ALLEGHENY COUNTY SANITARY AUTHORITY

CONTRACT NO. 1729 G, E, H, P

EAST HEADWORKS

ADDENDUM NO. 7

**530-A-23
EAST HEADWORKS
BUILDING SECTIONS**

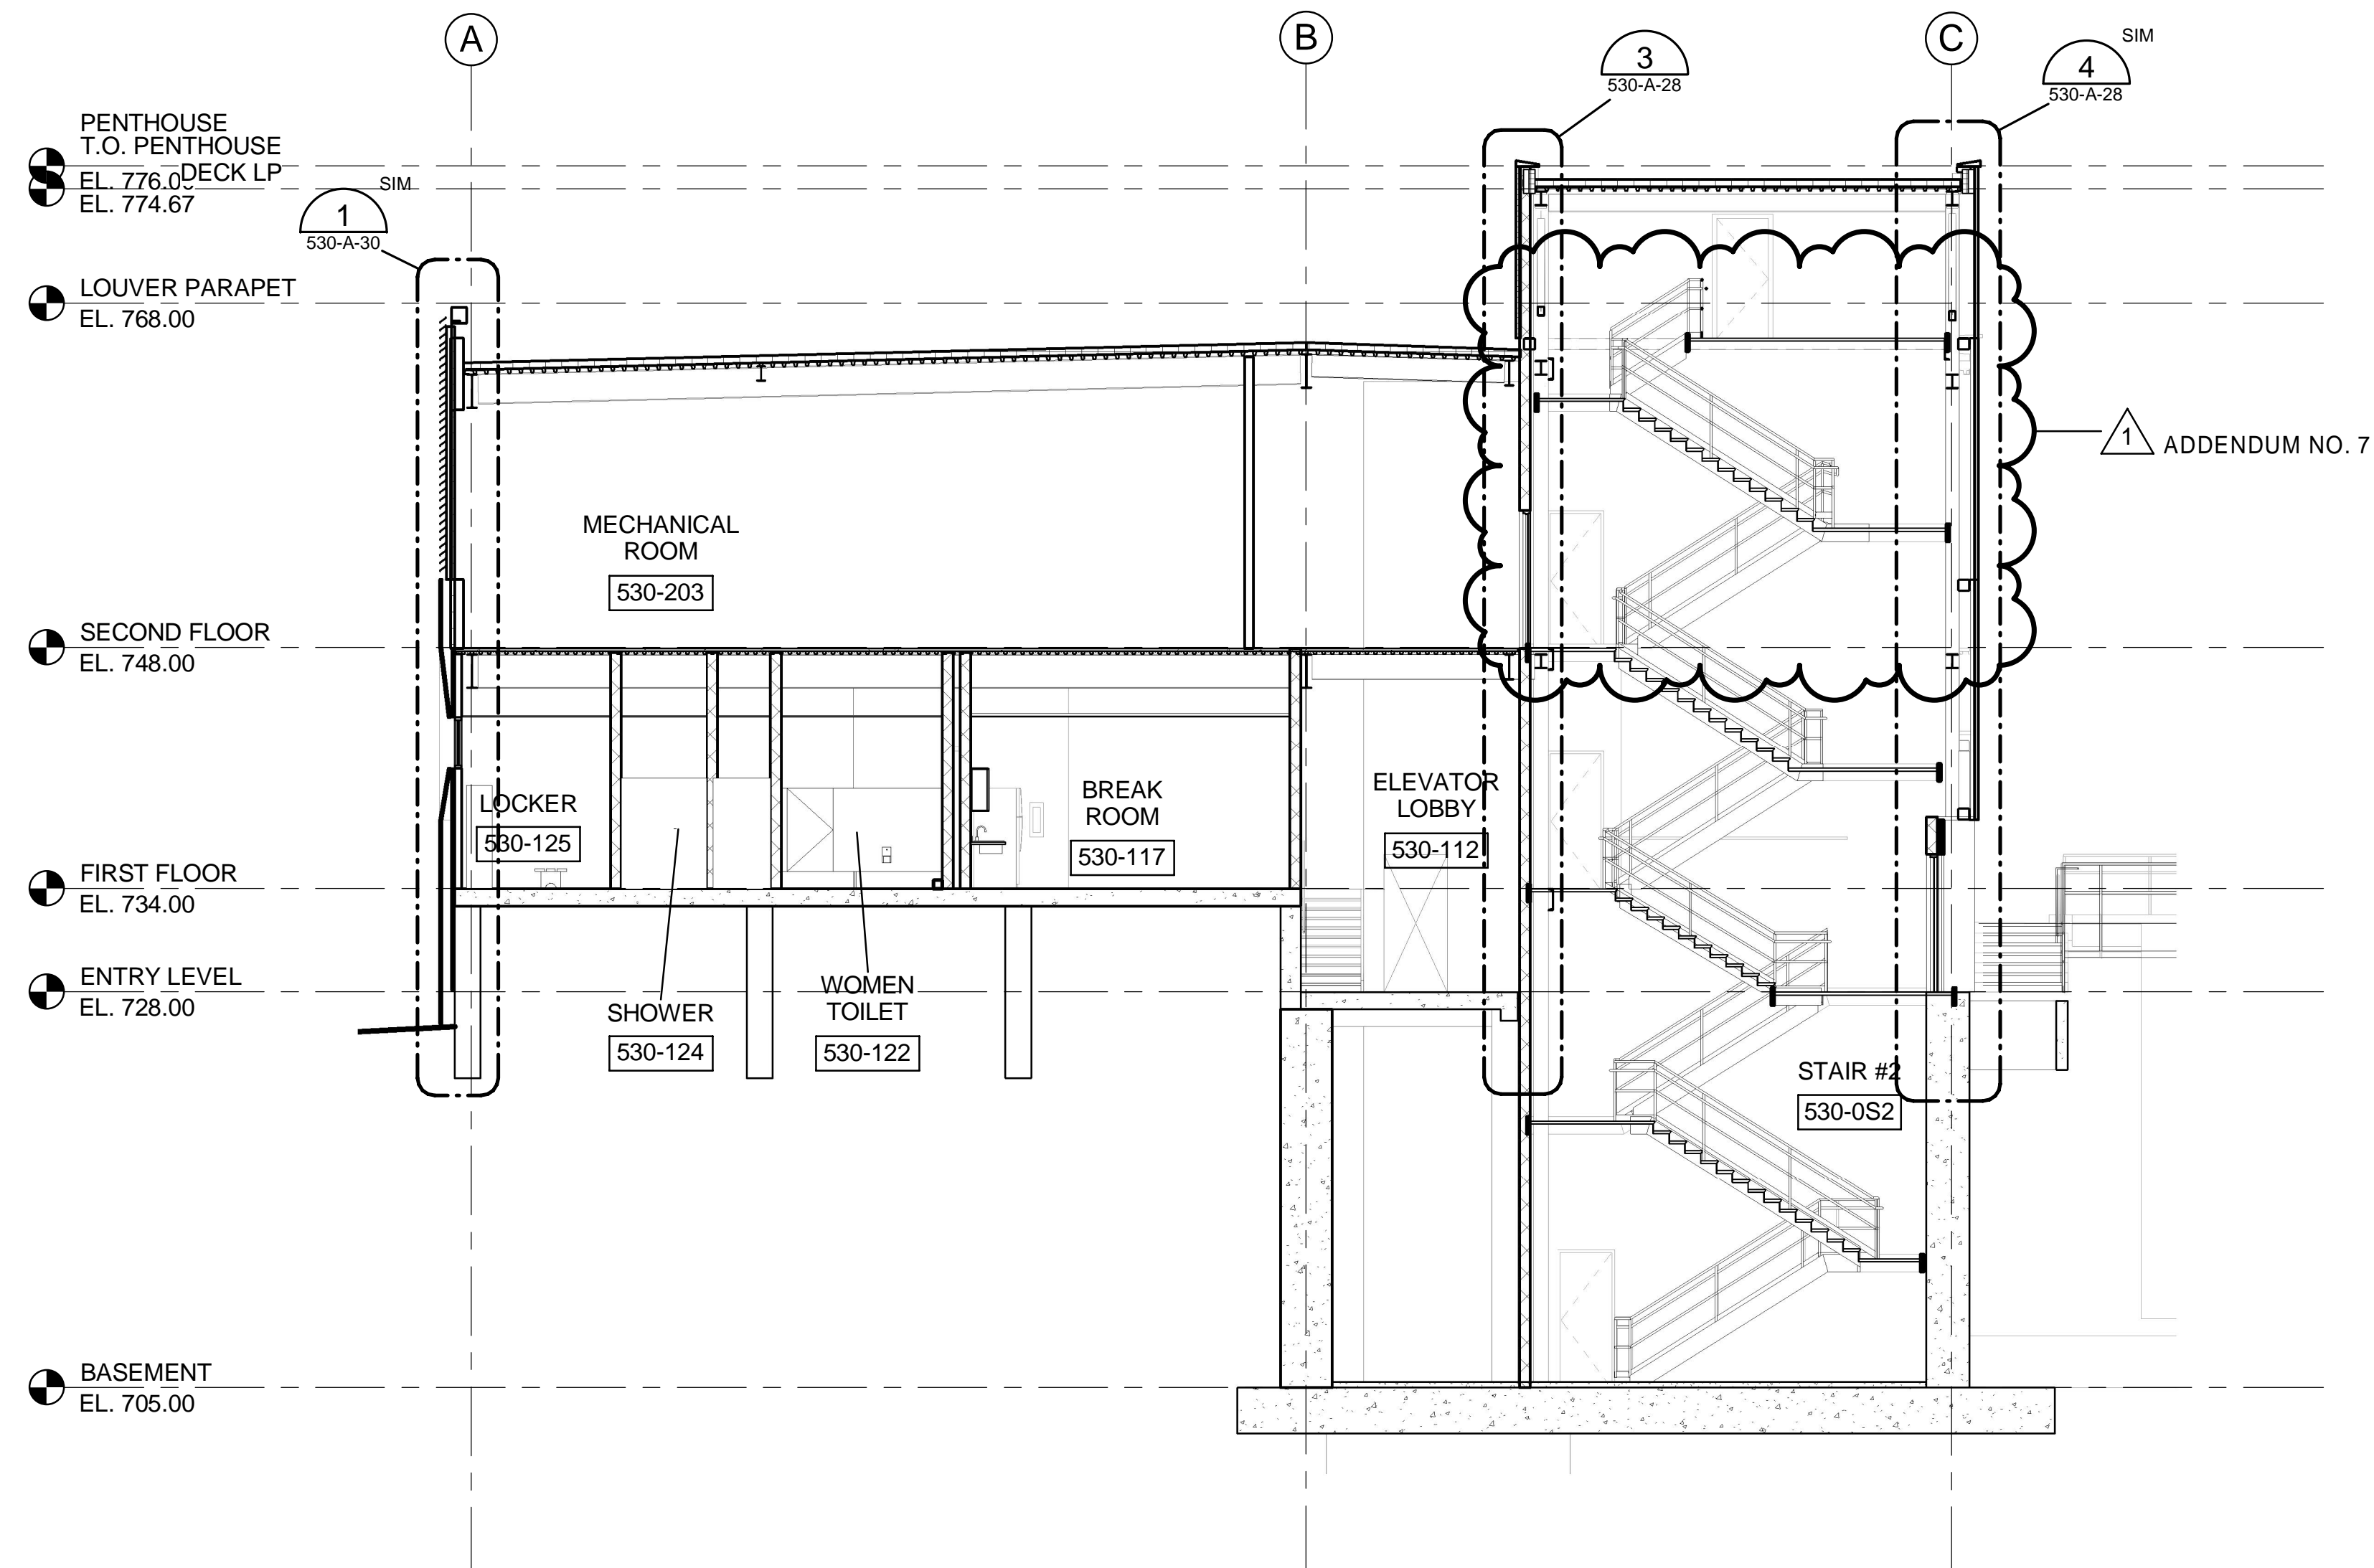
RESPONSE: The uppermost level of the stair was omitted from the drawing. The intent is for Stair 2 to terminate at the Penthouse Floor Level (Elevation 766). Refer to revised drawings 530-A-23, 530-A-28, and 530-A-36 through 39, issued with Addendum No. 7.

- c) **DELETE** this drawing and **REPLACE** with the attached drawing 530-A-23.

STAIR 1 SECTION 1
SCALE: 1/4" = 1'-0" 530-A-36

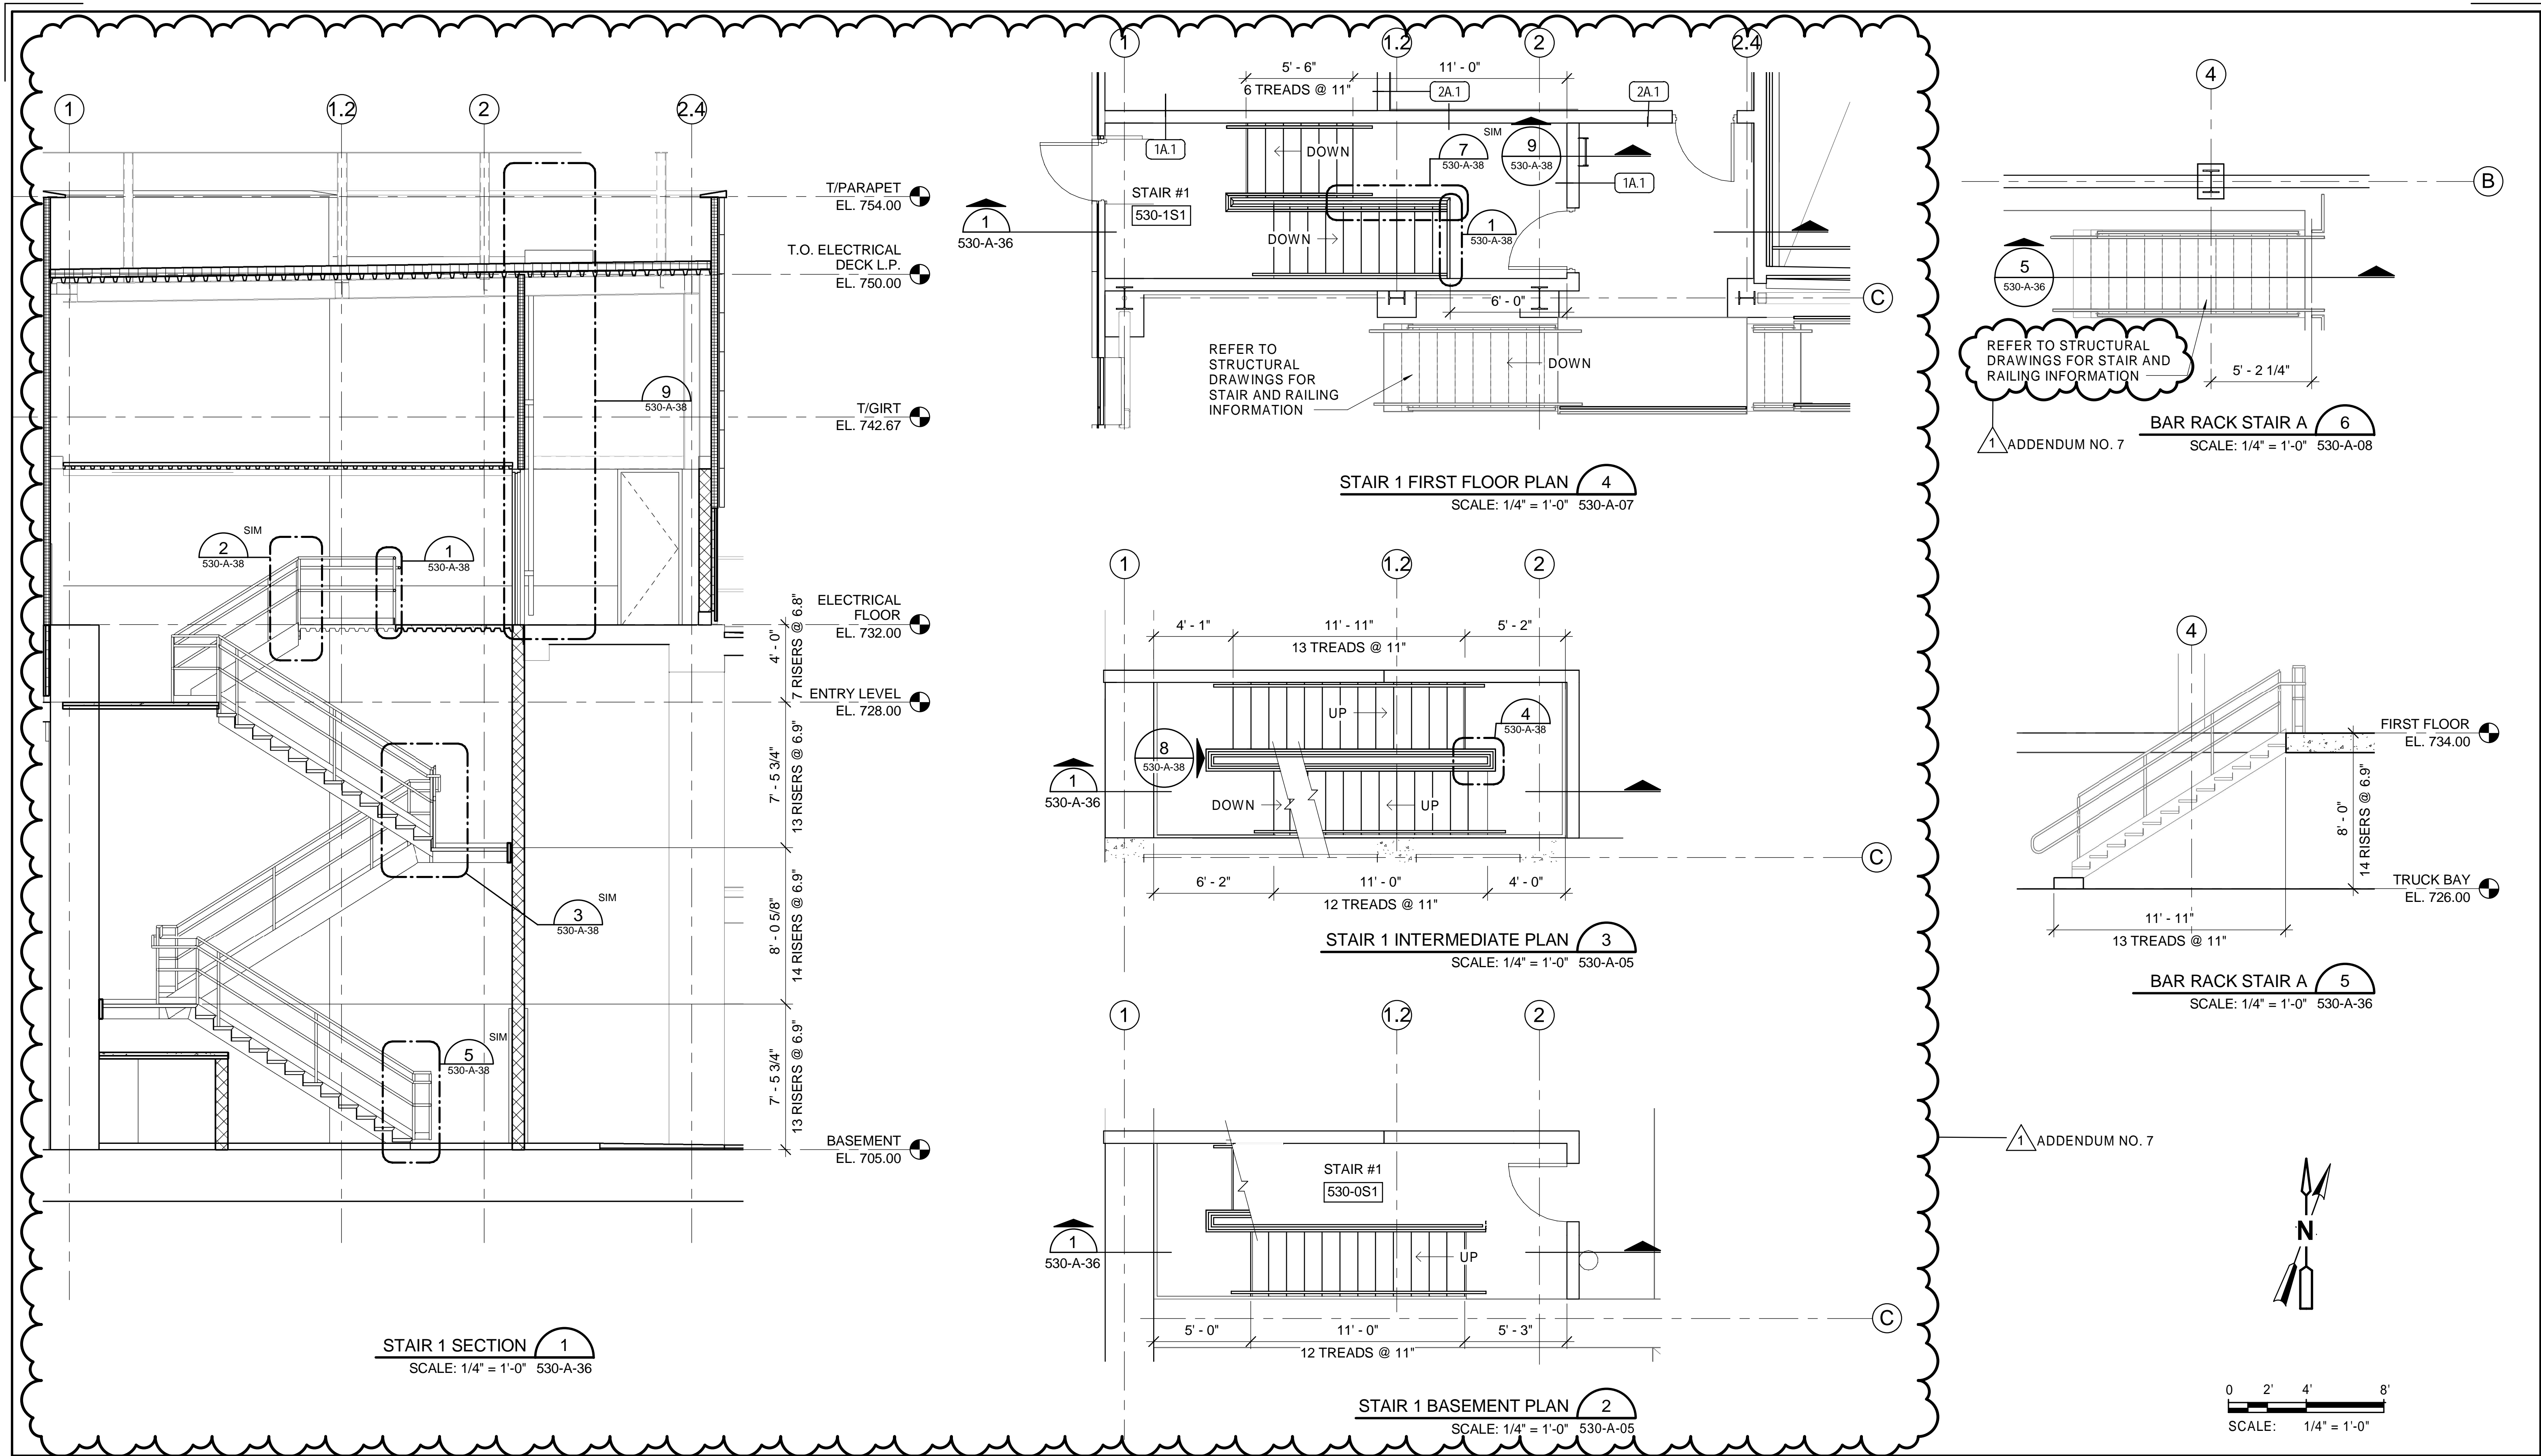
133. **QUESTION:** Reference drawing 530-A-37 (102 of 645), in section 1 for Stair 2 there are 2ea detail call outs numbered 1 and 3 from drawing 530-A-38 located near the top of the section view. On drawing 530-A-38 detail 1 and detail 3 are for railing details where there is not railing shown on 530-A-37. Also reference drawing 530-ELP-10 which shows the stairs extending to uppermost level of stair 2 as opposed to 530-A-37. It appears that drawing 530-A-37 may have been issued incorrectly and that the intent was to extend the stairs all the way to the top of the stairwell as indicated in 530-ELP-10. Please advise.

- c) DELETE this drawing and REPLACE with the attached drawing 530-A-36.
